LEGACY PROPERTY

URBAN DESIGN STUDY: RESPONSE TO COUNCIL COMMENTS

ORCHARD HILLS NORTH NEIGHBOURHOOD CENTRE

24/11/2022

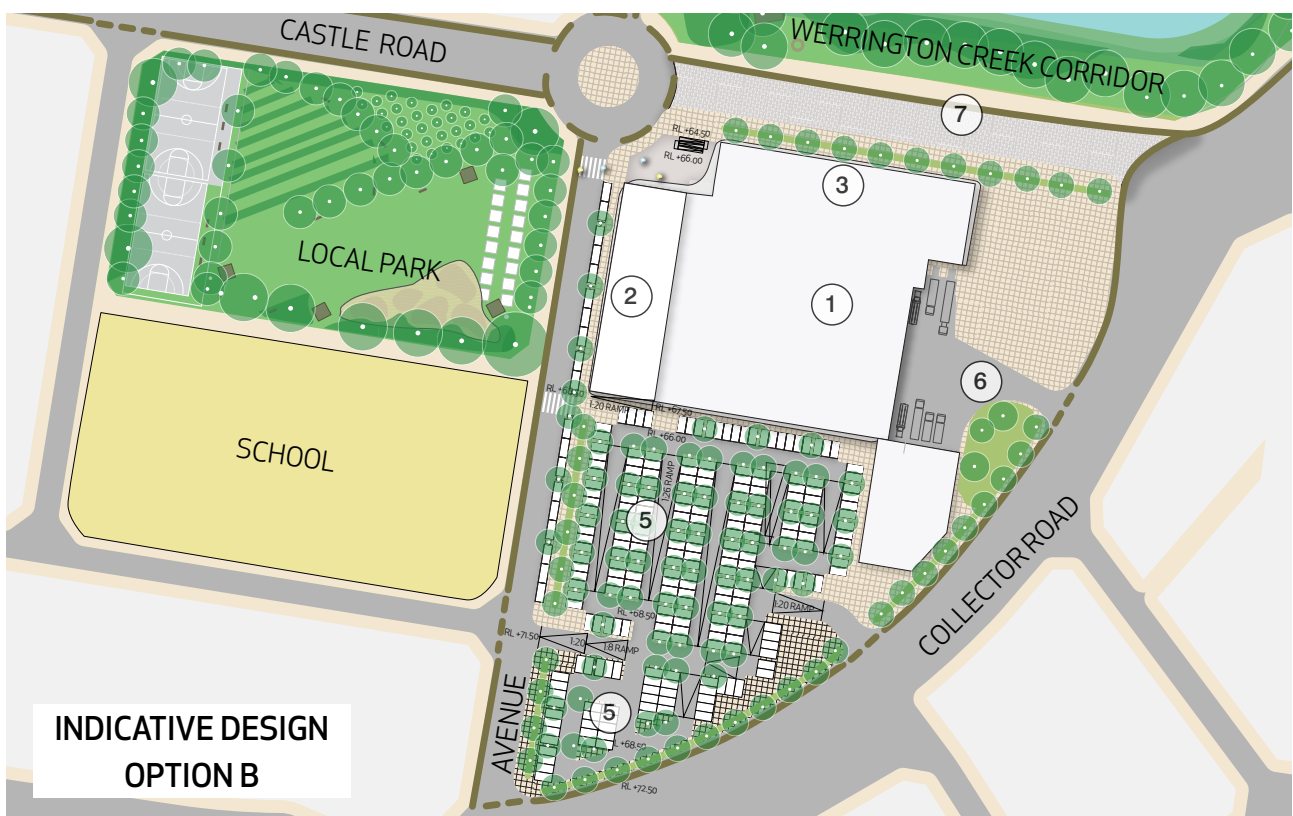
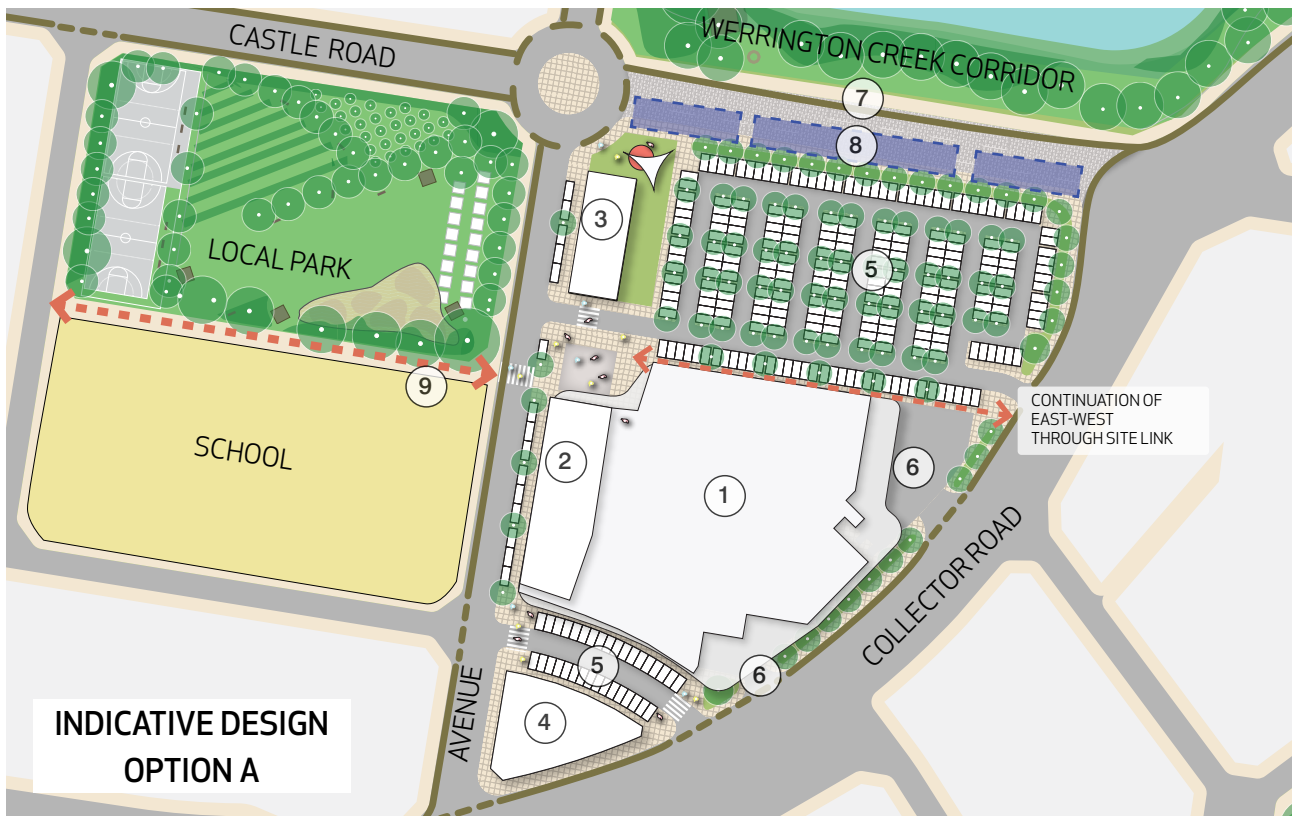
"There is a missed opportunity to capitalise on the green asset that is the Werrington Creek corridor. This 'green' land presents opportunities to 'create' a landscape feature that contributes to the character of the centre. Ideally the centre should be designed to address the green corridor and to integrate with it visually. Instead, the location of the main carparking area effectively isolates the centre from this green asset – including its connection to the broader pedestrian/cycle network linking the centre with the wider OH North and Caddens developments."

"Consider shifting the building footprint further north towards the north-west corner – with active frontages partly along the Local Park (as per the proponent's objectives) and partly along the northern pedestrianised section of Castle Road and Werrington Creek (finer grain retail wrapped around the building)."

"This northern edge of the building could:

**Capitalise on great views to the Werrington Creek Corridor*

**Offer outdoor uses with good solar access during the winter months*

**Activate the pedestrianised section of Castle Road"*

"Having a public square is a great idea – consider re-locating it to the north-west corner, activated by a chamfered building edge. This will then be located on a key desire path – between the Local Park and the Werrington Creek Corridor – and also offer good visual connection between the two."

We agree the Werrington Creek corridor is a fantastic asset that a retail centre design could potentially capitalise upon.

Nevertheless, AJC's current advice to Legacy is that the best place-outcome currently available for a retail centre anchored by a full-line supermarket in this location is one that orients itself to the Local Park to the west, rather than the Creek to the north. Our reasons for this advice are described on the next few pages.

However, in response to Council's valid points above: we want to emphasise that **the intent of the DCP Controls is to provide a flexible framework that creates principles and priorities without locking in a building envelope before a design brief is finalised.** This is precisely for the reason raised here. Area requirements for the supermarket box, parking and loading requirements vary significantly depending on the tenant type. A full-line supermarket is understood to be an absolute requirement for a viable retail development in current market conditions, and that requirement is currently influencing our advice. However, market conditions change, and if a small grocer-style supermarket is preferred in future then it could result in a reduced supermarket footprint, less specialty retail, fewer parking spaces and smaller truck/loading requirements. In this case, northern orientation to the Werrington Creek corridor may well be the superior outcome.

To test the best outcome for the current requirement for a full-line supermarket, AJC has prepared two studies. Option A, issued previously, orients towards the Local Park to the west. Option B moves the centre to better orient to the Werrington Creek corridor as well.

We absolutely support the notion that active/contributory frontage would be preferable along Werrington Creek. We focus first on activating open spaces, then on activating pedestrian-oriented streets, then activating or sleeving as many other street frontages as possible while still satisfying the large loading, parking and service requirements of the typology.

As will be described, we have explored an option to achieve the objective indicated in the comment above. However, our recommendation remains to focus active frontage on the western edge, as moving the building north to provide better frontage to the Creek creates trade-offs that we do not consider are sufficiently justified by the additional level of activation to the northern boundary.

The north-west corner does have those advantages, and we support the idea of using the plaza as a connection between the Creek and the Local Park via the retail centre.

However that location does come with trade-offs:

- The plaza sets the main retail floor level, and the northwest corner is the lowest level on site. This sets the design level for the whole retail site very low, which is likely to require significantly more extensive retaining walls than would be required if it was located at a mid- or high-point on the site.

- The northwest corner of the site is out of alignment with the Primary School and east-west link through the park/school site. This diminishes the relationship between the School and the Retail. The Option A location creates a three-way node of the park/school/retail connected by the east-west link.

- In the Option B arrangement, moving the plaza to the northwest corner moves it away from the parking lot. Given this is a suburban retail centre, the parking lot will be the main arrival point for the great majority of visitors. By not combining the square with the retail entrance from the car park, the activation of the public space will be significantly reduced.

AJC's advice is that, of the two options, the better location for the square is at the centre of the site.

Option B, Section along Collector Road

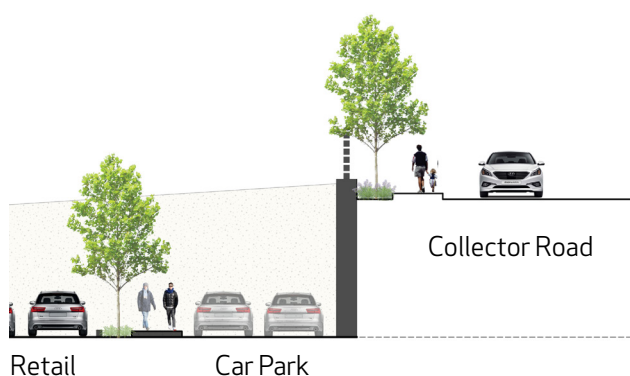
"the car parking area should be located either to the east or the south of the building. This will allow the building to naturally shade a part of the car park, particularly during the afternoons."

The condition described above - using the building to shade the retail entrance facing the parking by positioning the main lot - would be our preference. However, the site has a steep south-to-north fall.

Surface parking should always have minimal slope to prevent trolleys from rolling, but in particular that slope cannot be uphill from the entrance or else it becomes difficult for less mobile customers to push their trolleys to their vehicles. Positioning the parking to the south of the building results in the flat parking level being set down significantly from the street, requiring tall retaining walls and negatively impacting street quality.
